Land Use Committee Report

City of Newton **In City Council**

#27-20 Petition to allow Mixed Use Transit Oriented Development at Riverside Station
MD 399 GROVE OWNER, LLC/RAMIREZ CONCORD, LLC/BH NORMANDY RIVERSIDE, LLC/MASSACHUSETTS BAY TRANSPORTATION AUTHORITY petition for SPECIAL PERMIT/SITE PLAN APPROVAL to construct a mixed use, transit-oriented development of residential units, office, retail, personal services, restaurant, hotel, and related commercial uses not to exceed 1,025,000 square feet of gross floor area, with residential uses comprising not less than 60% of the total gross floor area with a residential density of not less than 800 square feet per unit with not less than 560 units nor more than 620 units with special permit relief and/or waivers as follows: as to dimensional standards, a development of more than 20,000 square feet of gross floor area, building height of up to 170 feet, buildings up to 11 stories, Floor Area Ratio of up to 2.5, beneficial open space of not less than 15%, increase of height of certain buildings with the Grove Street Area Corridor (to the extent necessary), and reduction in setback from Grove Street for certain buildings within the Grov

Grove Street Cross-Section- 95 Overpass (Looking Northeast)

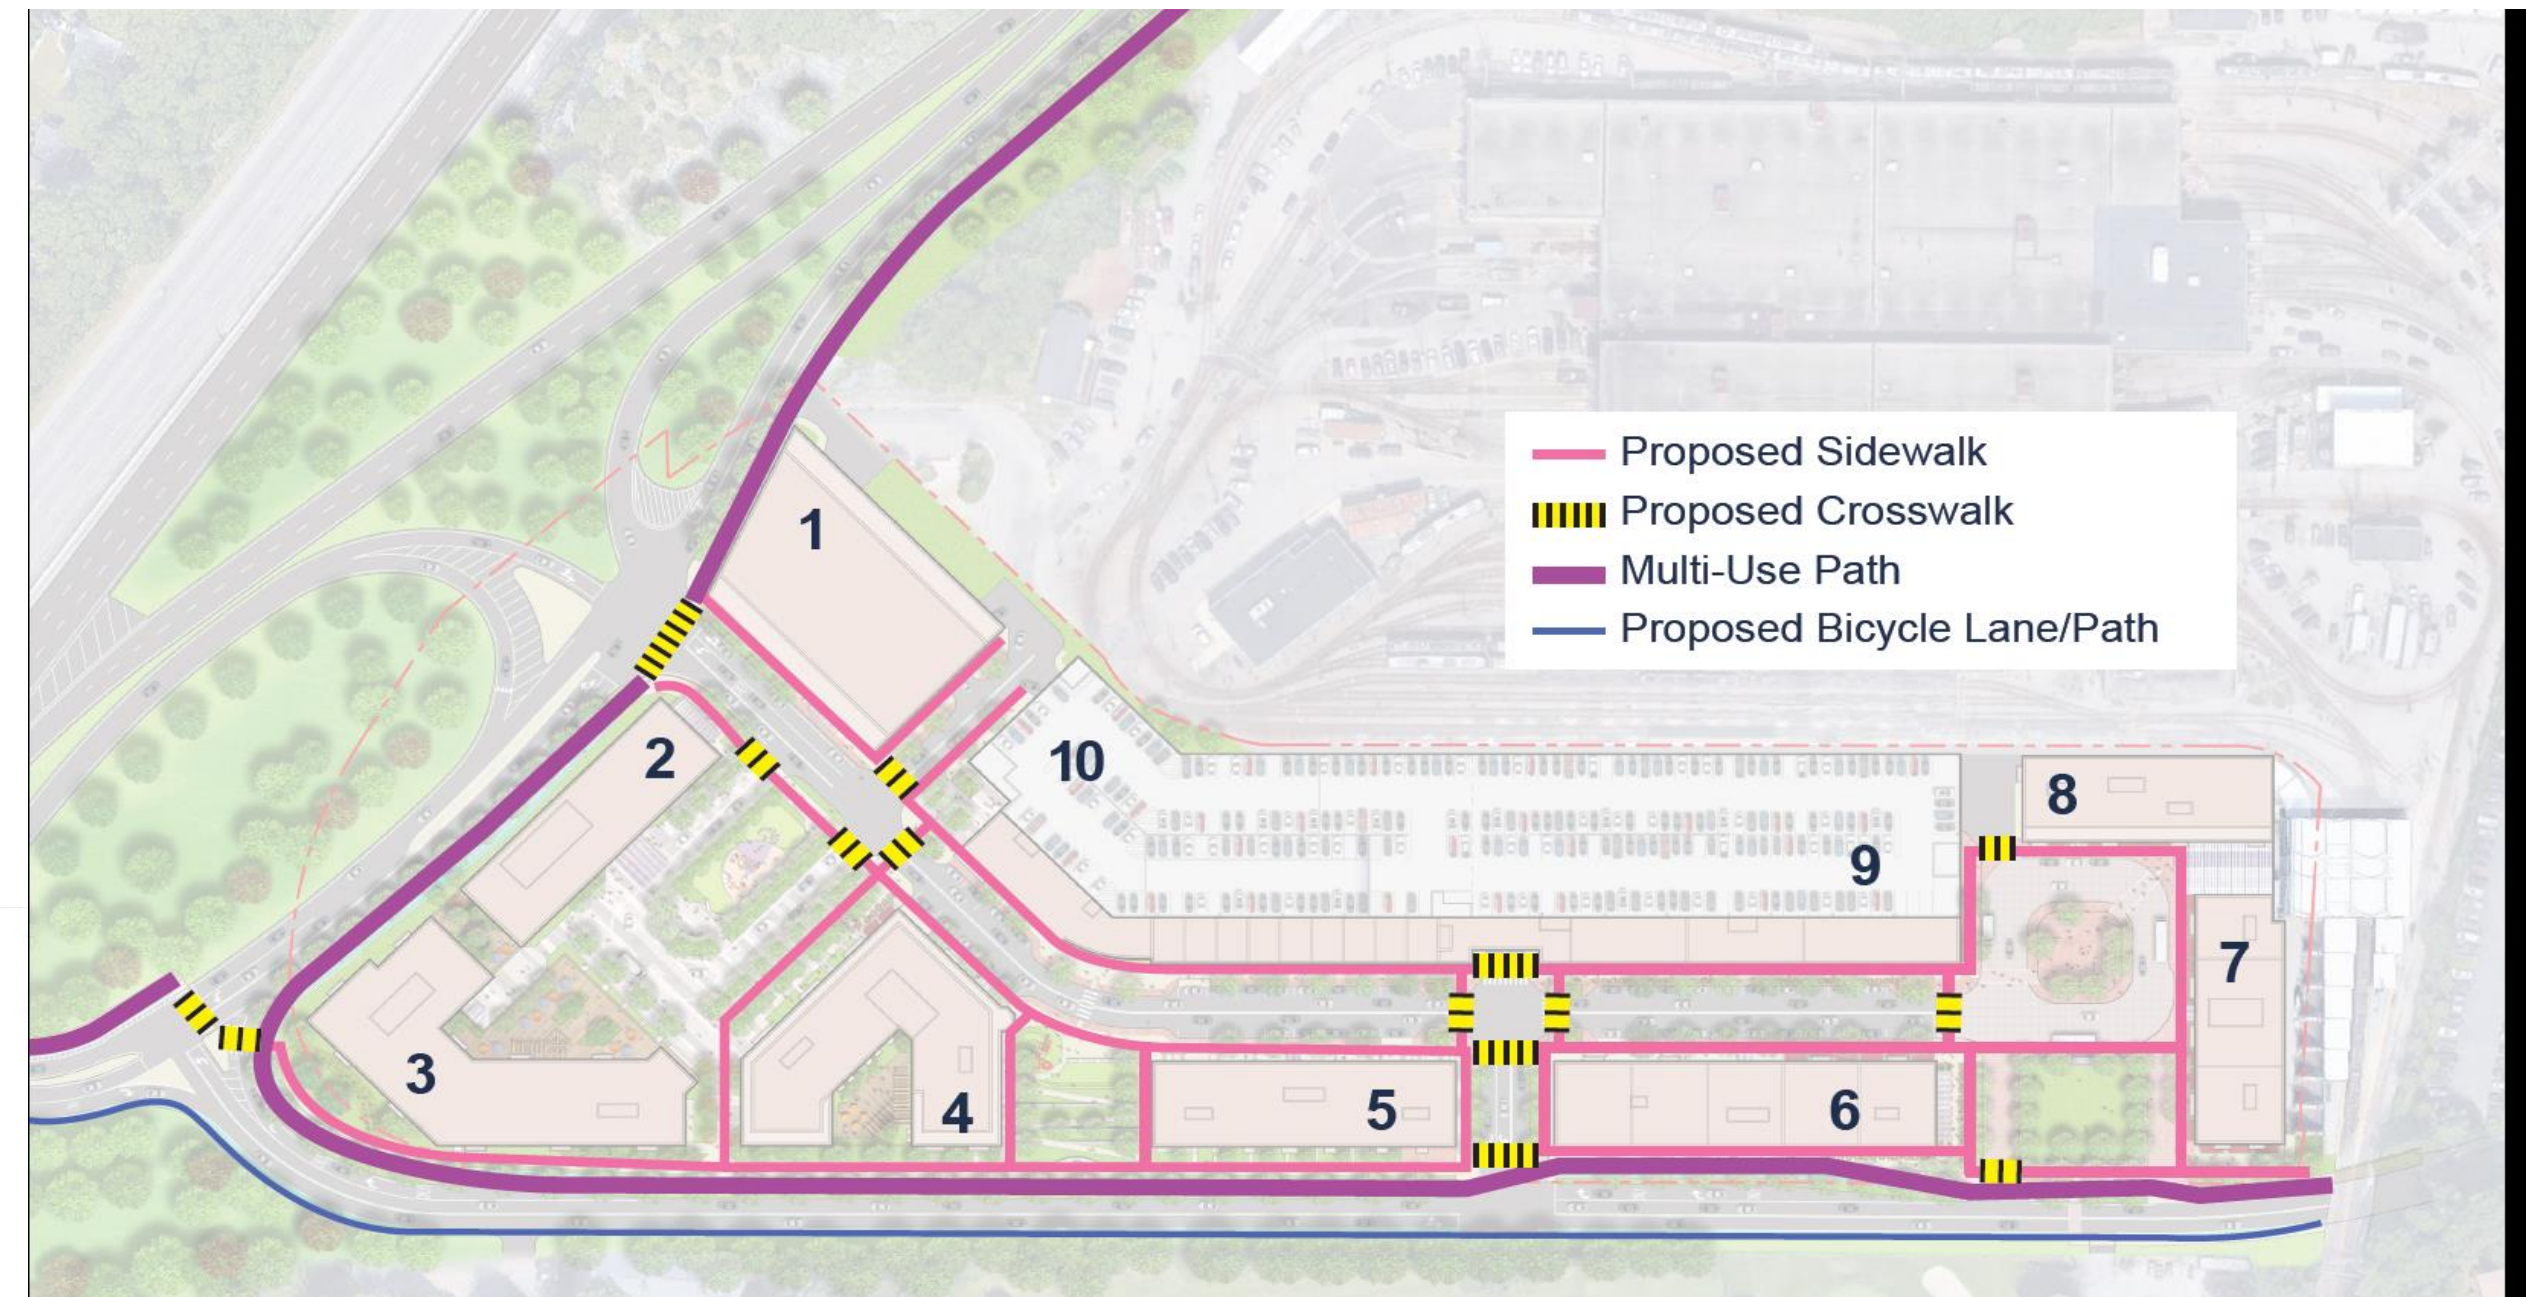
- *“The proposed shared-use path should be extended to Recreation Road, rather than ending at the bridge over the Charles River as currently proposed. We recommend a 14’-wide shared bicycle/pedestrian path on the northeast side of the road in order to provide two-way access for all users while ensuring separation from vehicular traffic entering and exiting the highway. This would still maintain sufficient right-of-way on the existing bridge structure for two 11’ vehicular lanes”*

Internal Driveway Queues – Weekday Morning Peak Hour

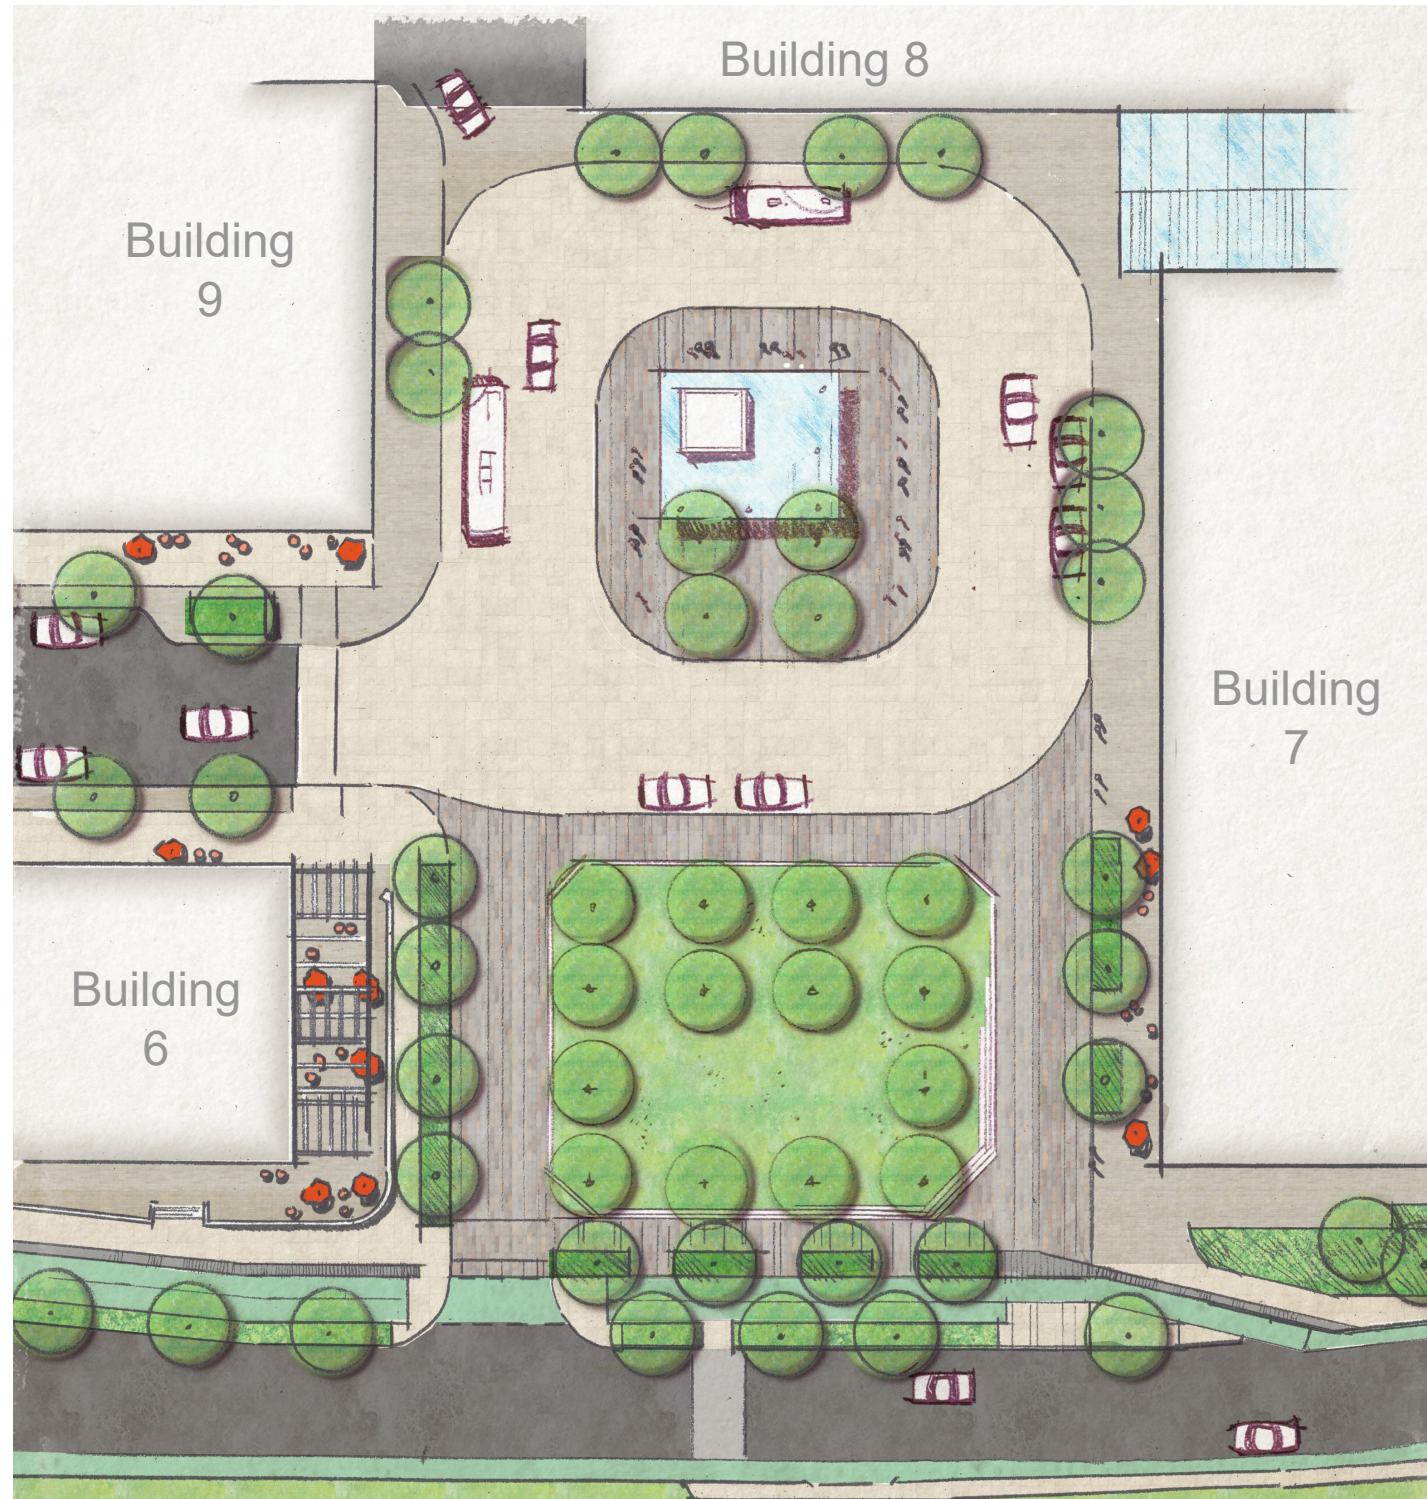
- *“Internal intersection queueing”*
